**From:** Govan, Tekia  
**Sent:** Wednesday, June 01, 2011 10:34 AM  
**To:** 'Bense, Richard'  
**Cc:** STPCOL  
**Subject:** Chapter 2 PROP determination and Fact Check  
**Attachments:** STP SER Sections 2 1-2 3\_OGC incorp\_FINAL.docx; STP\_SER\_2\_4\_with\_no\_OIs-FINAL.docx; STP-SER Phase 4 Section 25S\_OGC\_Incorp\_FINAL.doc

We are currently processing the official letter to STP which will carry the Chapter 2 SER with no OIs. Attached please find the courtesy copy of Chapter 2 – Site Characteristic for your PROP determination and fact check.

## 2.0 SITE CHARACTERISTICS

Figure 2.3S.3-3 STP Stability Class Frequency Distributions.

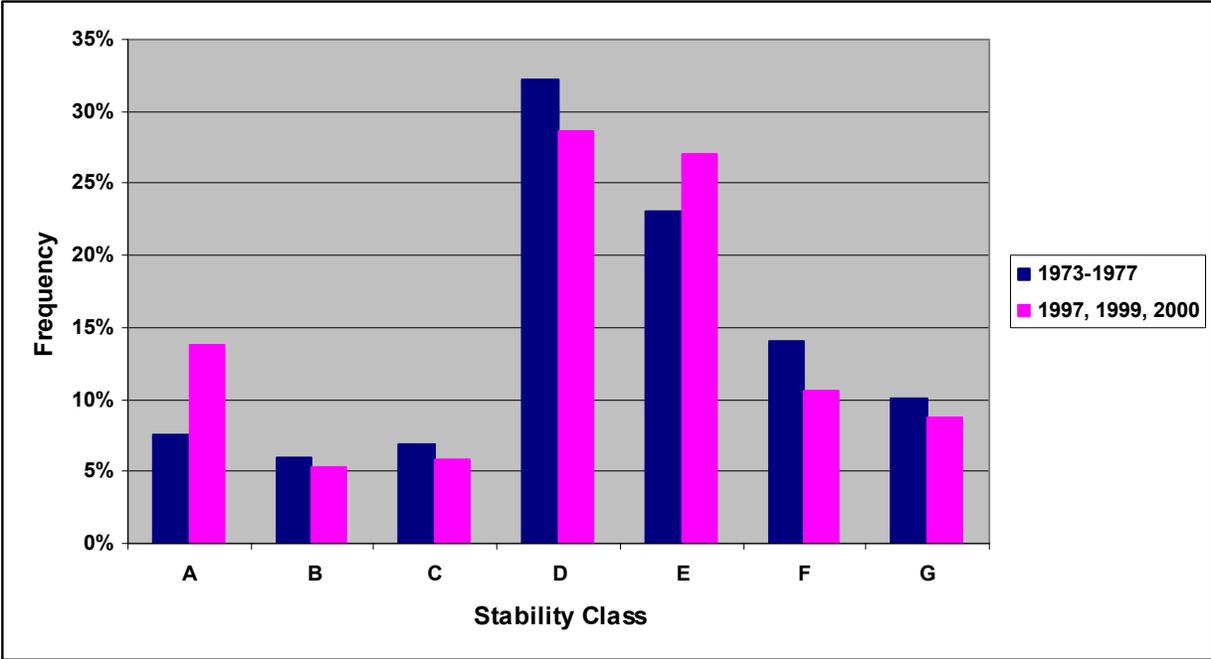
The stability class frequency distribution for both data sets in SER Figure 2.3S.3-3 also show reasonable agreement. Nonetheless, the staff issued **RAI 02.03.03-3** asking the applicant to explain the 6 percent frequency increase of onsite Stability Class A (extremely unstable) conditions from the original data set to the current data set (see SER Figure 2.3S.3-3).

Figure 2.5.1-3 Tectonic Figures in the STP Site Region (FSAR Figure 2.5S.1-17)

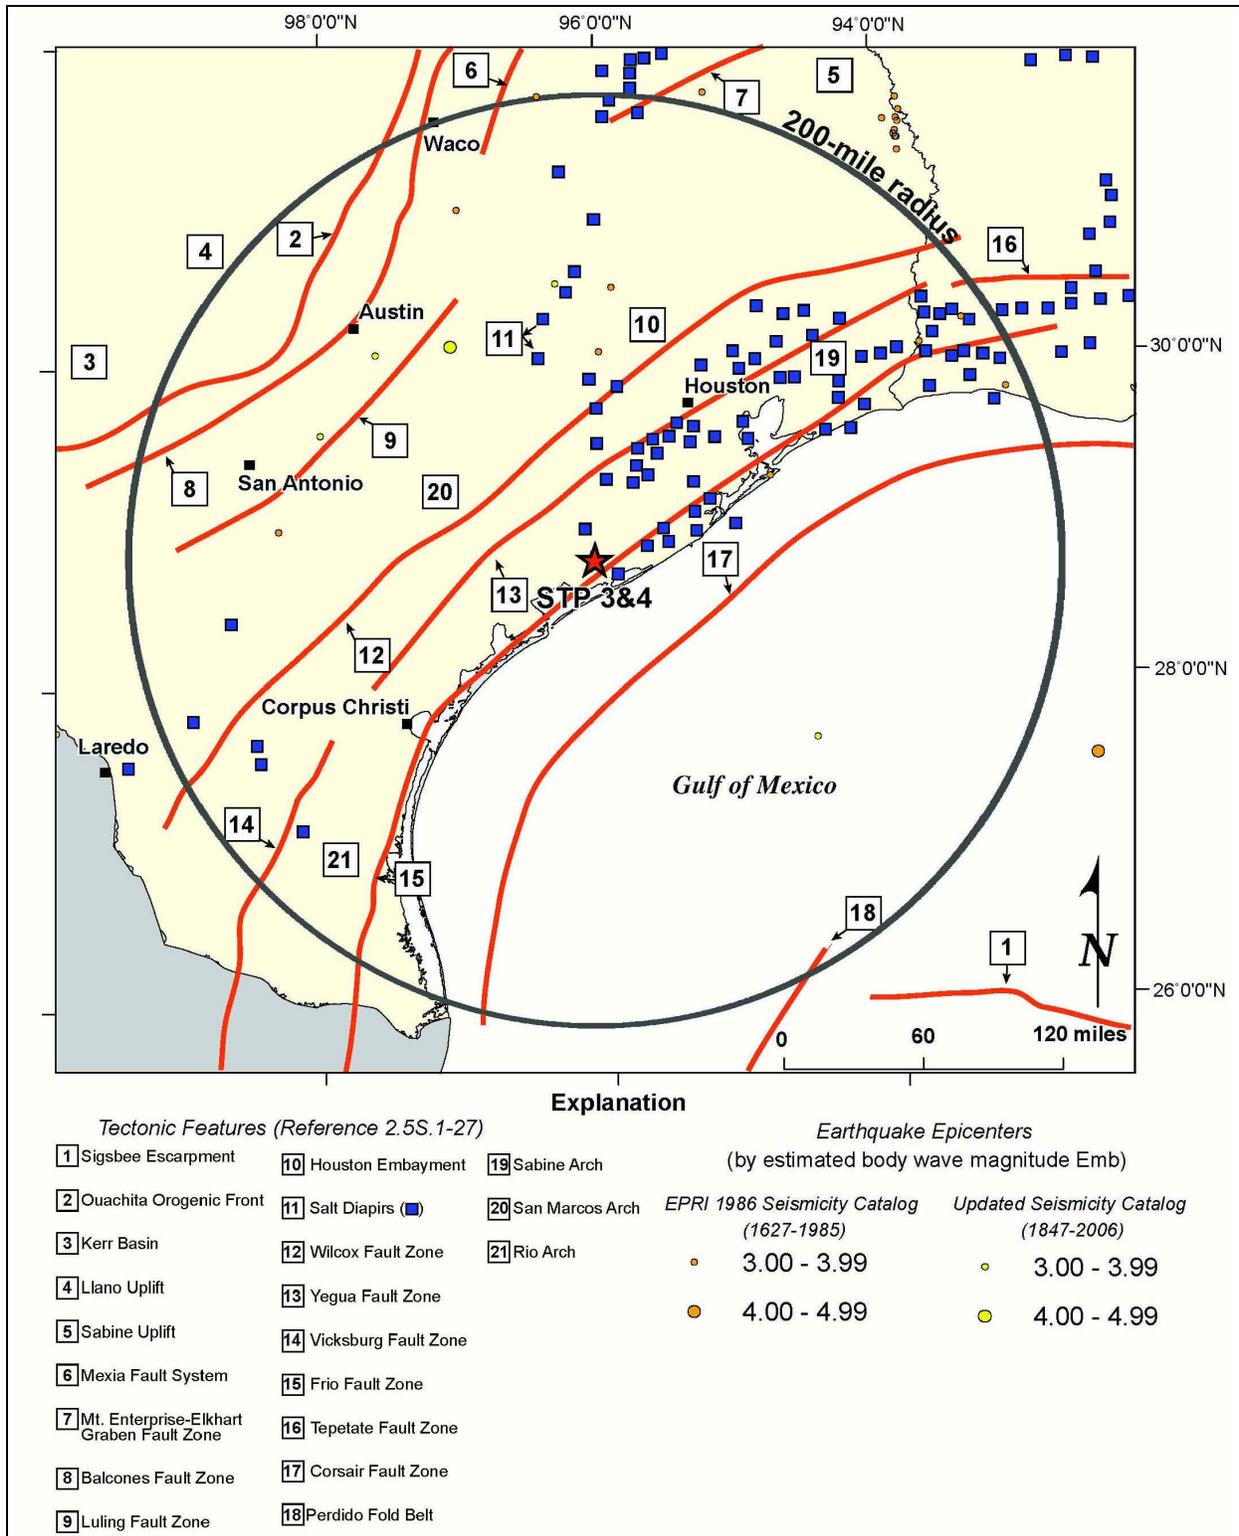
symbols and colors used to identify earthquakes and salt diapers in FSAR Figure 2.5S.1-17. In response to **RAI 02.05.01-5** dated June 26, 2008 (ML081970231) and RAIs **02.05.01-2** and **02.05.01-17** dated July 9, 2008, the applicant provides all corrections and clarifications. Therefore, **RAI 02.05.01-2**, **RAI 02.05.01-5**, and **RAI 02.05.01-17** are closed.

Figure 2.5.1-5 Map of Growth Fault Projections, Lineaments, and Topographic Survey Points Within the STP Site Area (Reproduced from FSAR Figure 2.5S.1-45).

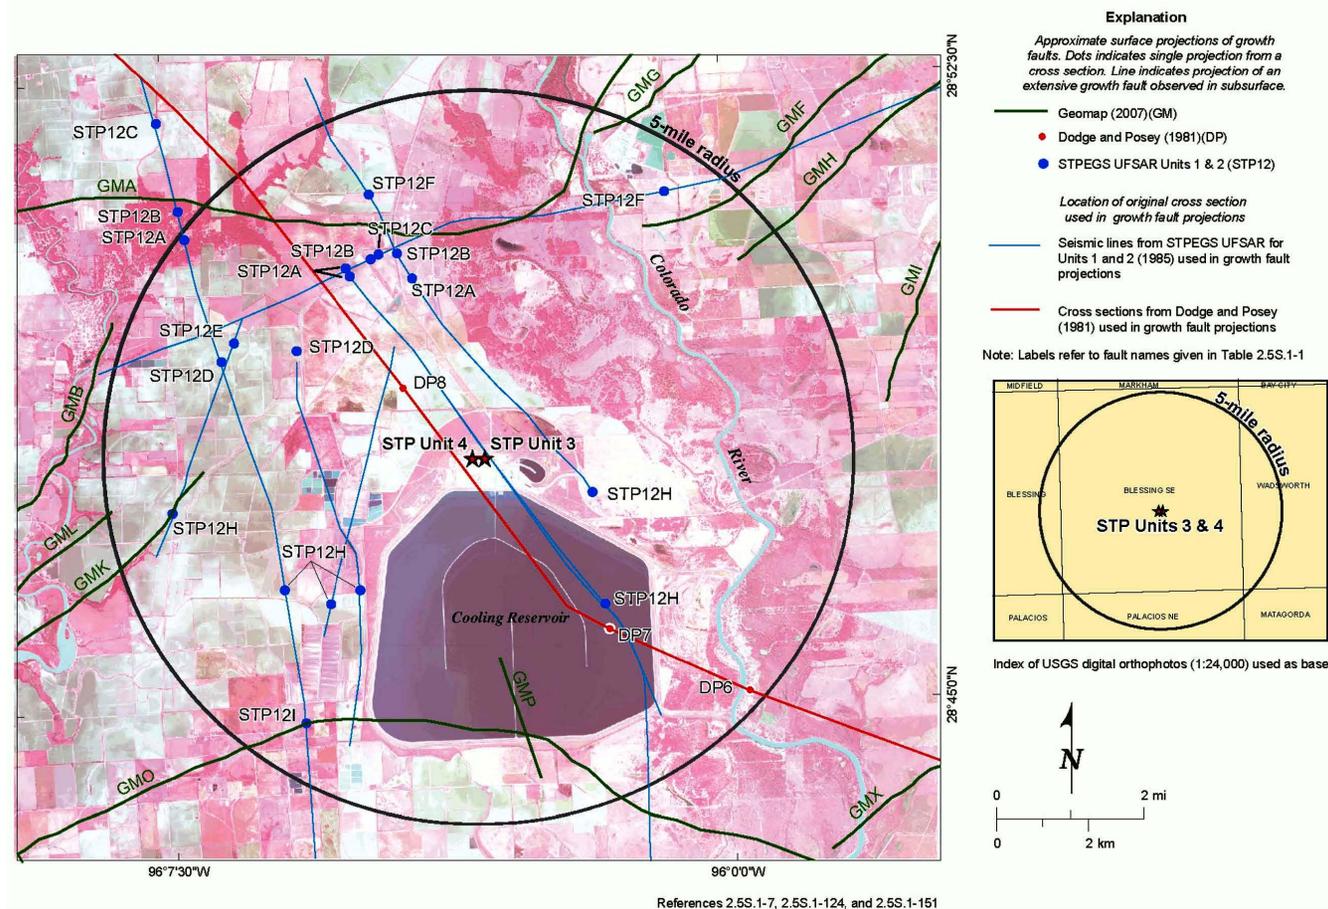
SER Figure 2.5.1-5 (based on FSAR Figure 2.5S.1-45) shows linear features within the cooling reservoir that represent slope breaks and vegetation lineaments along strike with growth fault Matagorda STP 12I (Matagorda GMO). The staff issued **RAI 02.05.01-20** requesting the applicant to evaluate whether these linear features represent a northeast extension of growth fault Matagorda STP 12I (Matagorda GMO), which is different from the projection shown in SER Figures 2.5.1-4 and 2.5.1-5.

The staff reviewed the applicant's response to **RAI 02.05.01-20** and acknowledged that the applicant has performed a robust investigation of growth fault Matagorda STP 12I/GMO based on the applicant's inferred surface projection of growth fault STP 12I/GMO. Furthermore, the staff acknowledged that the linear features identified within the cooling reservoir in SER Figure 2.5.1-5 (FSAR Figure 2.5.1-45) are now covered and therefore, the applicant cannot investigate them further. The staff concluded that the applicant's response to **RAI 02.05.01-20** provides an acceptable evaluation of the projected trace of STP 12I/GMO given the lack of more convincing field observations, and the inability to further evaluate the linear features beneath the cooling reservoir. Therefore, **RAI 02.05.01-9**, **RAI 02.05.01-10**, and **RAI 02.05.01-20** are closed.

Figure 2.5.4-12 Plot of All Data Showing Plan Locations in All Strata of Soils Exhibiting a Factor of Safety Less Than 1.40 for Three Methods of Investigation (RAI 02.05.04-28 Response Figure 50).

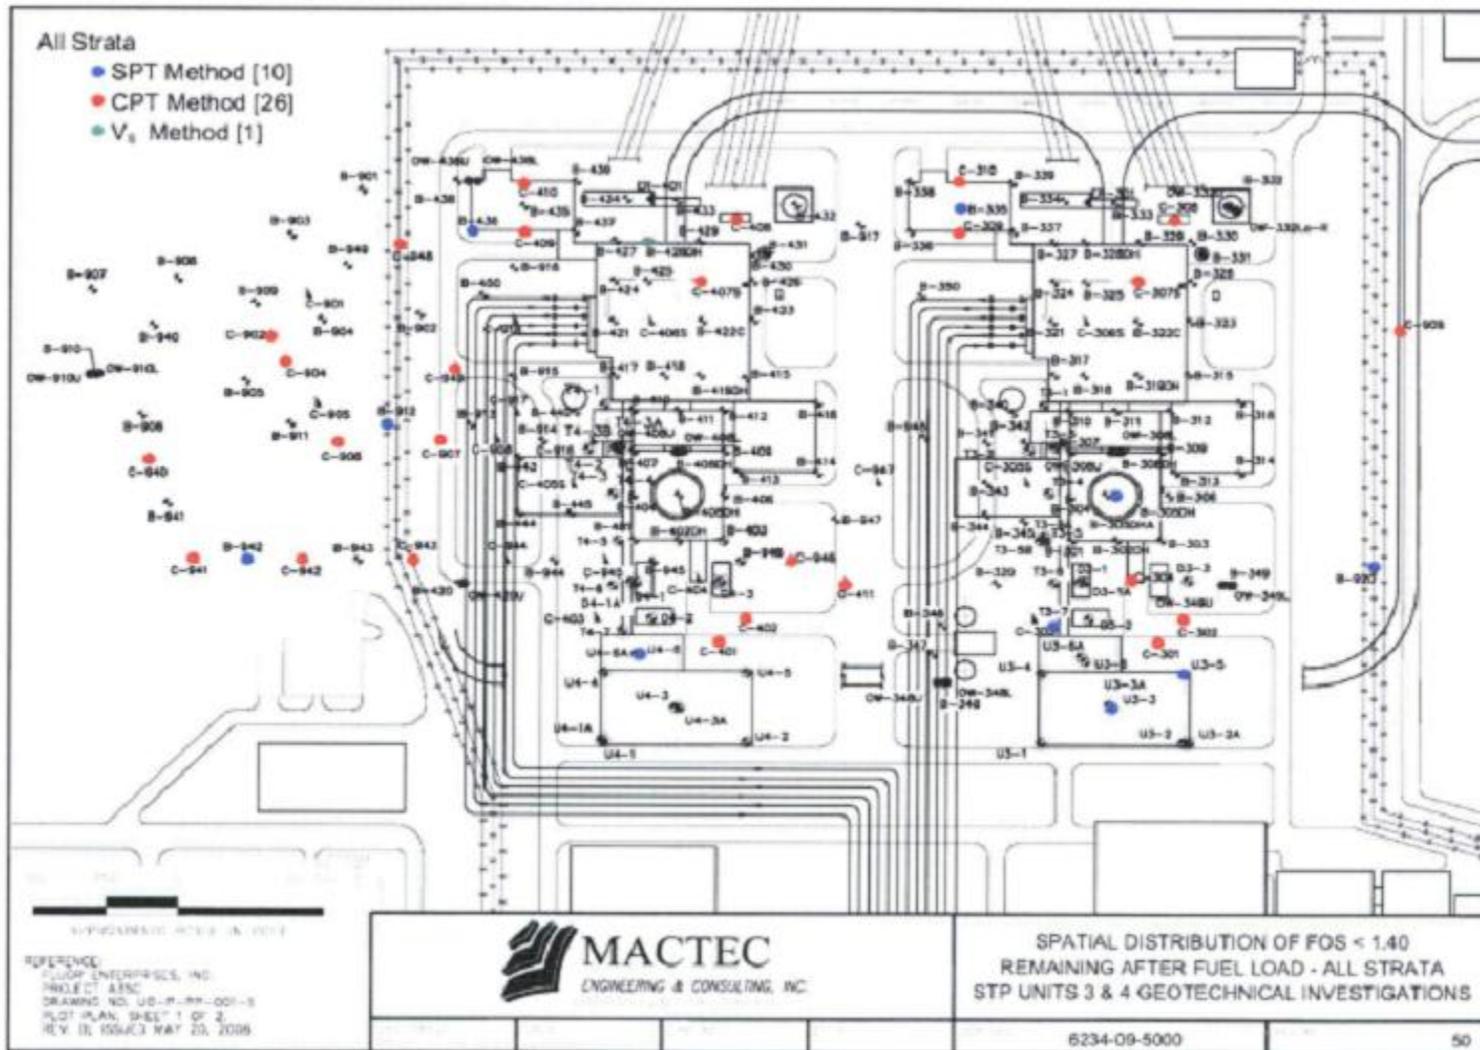
The applicant concludes that the Beaumont formation is geologically old, and the incorporation of a correction factor for age will likely increase factors of safety above the 1.4 threshold. The applicant further concludes that although quantitative data to support an age correction factor are lacking, the age of the deposit is sometimes accounted for by omitting the correction factor for stress (Ks factor). Using a simple calculation, the applicant demonstrates that omitting the Ks factor is substantial enough to increase computed factors of safety above 1.4. The staff finds this acceptable. Therefore RAI 02.05.04-5 and RAI 02.05.04-28 are closed.
